UNITED STATES PATENT AND TRADEMARK OFFICE

10/613,256

Office Action Summary	Application No. 10/613,256	Applicant(s) REICHERT, GERHARD	
	Examiner NAHID AMIRI	Art Unit 3679

DETAILED ACTION

Fig. 4

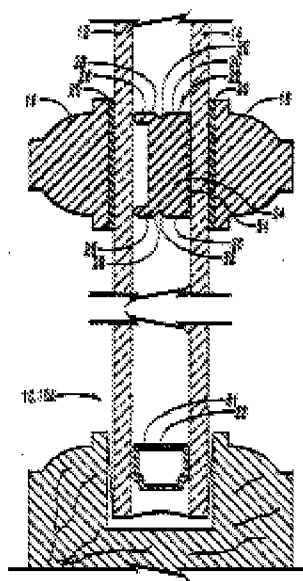
With respect to claims 62-75, 78-82, and 84-93, Baier discloses a simulated divided lite insulating glazing unit (Fig. 4) comprising first and second spaced glass panes (12, 14) spaced apart by a perimeter spacer (12), the first and second glass panes (12, 14) and spacer (12) defining a gap, a resilient foam internal muntin bar (22) disposed inside the gap which inherently is capable of being rolled into a roll for storage and shipping and then unrolled for application to the glass; the internal muntin bar (22) dividing the gap into separate portions to provide a divided-lite appearance to the glazing unit; the internal muntin bar (22) having a body having a longitudinal direction, the body having opposed base walls (24) separated by the height of the

body; one of the base walls (24) having an adhesive (34) that connects the base wall (24) to an inner surface of one of the glass panes (14); the base wall having the adhesive (34) defining a body width the body being formed from a body material; and wherein (column 2, lines 60-64) that the body of muntin bar (22) is fabricated from a foam polymer and the foam includes a desiccant. Baier does not disclose the body defining at least one insulating cavity. Milikovsky teaches a window unit (Fig. 2) having glass panes and a spacing elements (3) between glass panes (2 and 4); the spacing elements (3) defining a body (B), the body (B) defining a plurality of insulating cavities (C); wherein the cross section of body material (B) being larger than the cross sectional area of the insulating cavities (C); wherein the body (B) defining a longitudinal direction; and each of the insulating cavity (C) extending continuous in the longitudinal direction; the cavities (C) are spaced apart from one another; and wherein the cavity (C) has a width, the space between the cavities (C) being equal to or greater than the width of either cavity. It would have been obvious to one of ordinary skill in the art at the time of invention was made to provide the muntin bar of Baier with a plurality of insulating cavities as taught by Milikovsky for any of the reasons known in the art. For example, increase the resiliency of the body and/or reduce the effectiveness of the thermal bridge resulting from the muntin bars contacting both sheets of glass.

FIG. 1
STATE OF THE ART

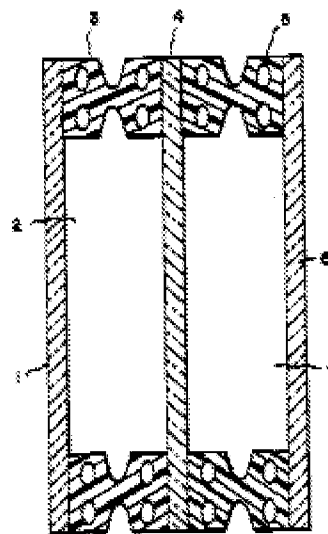
As stated in previous Office action mailed on 31 December 2007, the Examiner points out that one is to presume skill on the part of one of ordinary skill in the art, not a lack of skill. *In re Sovish*, 226 US PQ 771 (CCPA 1985). The illustration present in Milikovsky is exactly the same as applicant's illustration of cavities and thus clearly constitute cavities as readily apparent to any person having ordinary skill in the art. Moreover, it is well-established that one of ordinary skill knows something about the art apart from what is explicitly written in a reference document.

Further, with respect to Milikovsky, applicant argues that since there is no discussion of what the illustrated feature is, it is improper for the examiner to assume that the feature represents cavities. This is not persuasive. In particular, it is first noted that the illustration of Milikovsky is the same as that used by applicant. Accordingly, how is it that the illustration represents “cavities” when used by applicant, but the same illustration in a prior art reference does not represent “cavities”?

Second, Milikovsky clearly identifies this feature as something that was part of the “state of the art” at least as of 1996 when the application was filed. Being that this feature was part of the state of the art” years before applicant’s instant invention, it certainly is not unreasonable to expect that those of ordinary skill in the art would know what the feature is and why such feature would be present. Applicant makes the allegation that “Nothing in Milikovsky discloses or teaches the use of cavities in the body of the spacer”, e.g., see page 8. No basis for this statement is set forth and the figures of Milikovsky indicate otherwise since cavities are shown in the body of the spacers. Nevertheless, applicant appears to be seeking to present a position that questions the accuracy of the examiner’s stated interpretation of the factual technical information of the “state of the art” acknowledged by Milikovsky. Accordingly, in accordance with 37 CFR 1.105(a)(1)(viii), applicant is required to submit information known to him concerning what the state of the art was and what the illustrated features (identified as cavities by the examiner) are, if not in fact cavities.
